# **Transtech** **Bulletin**

**Application: Volkswagen/Audi**

**Subject: 097/01N Pan Gasket 1995-Up with Lock-up**

TB 17 12/2000

TransTec #33002  
OEM #01N-321-370

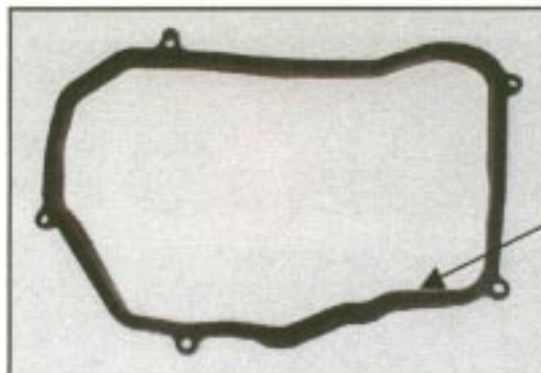
In 1995 when Volkswagen/Audi revised the product designation of the 097 to 01N, they also changed the shape of the molded pan gasket slightly. As little as the change is, there is no interchange between the 097 and 01N parts.

Old Style

New Style

Slight Difference

TransTec's part number is #33002, OEM #01N-321-370. Please see the illustration below.
